Access Compliance Report

Public Rights-of-Way

(Pedestrian Signals)

Intersection ID: N/A	Main Street:	Cross Street: N/A	Location: N/A
ADA ID: 55ED222B5917	Signal Type: One Push Button-Non APS	Overall Compliance: No	Severity Score: BTN 1: N/A BTN 2: N/A No BTN: N/A
Codes/Mitigation Info/Possible Solution		Field Measurements/Component Compliance

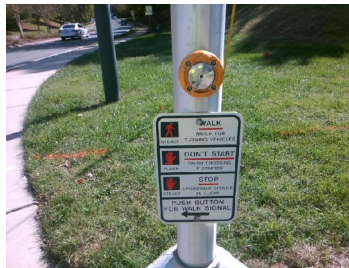
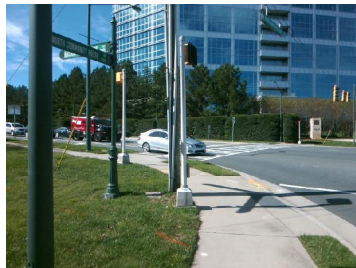
Yes	B 1 Clear Xing Direction?	ClearlyMarked	N/A	B 2 Clear Xing Direction?	N/A
	B 1 Crossing Direction	To NE		B 2 Crossing Direction	N/A
Yes	B 1 DistanceTo XWalk (in)	32.0	N/A	B 2 DistanceTo XWalk (in)	N/A
No	B 1 DistanceTo Curb (in)	99.0	N/A	B 2 DistanceTo Curb (in)	N/A
Yes	B 1 Diameter (in)	2.0	N/A	B 2 Diameter (in)	N/A

Possible Solutions: Replace Signal Push Button With APS Button on New Post. Remove & Relocate Sign.

PROW/ADA: TMUTCD 4e.08, R406.2
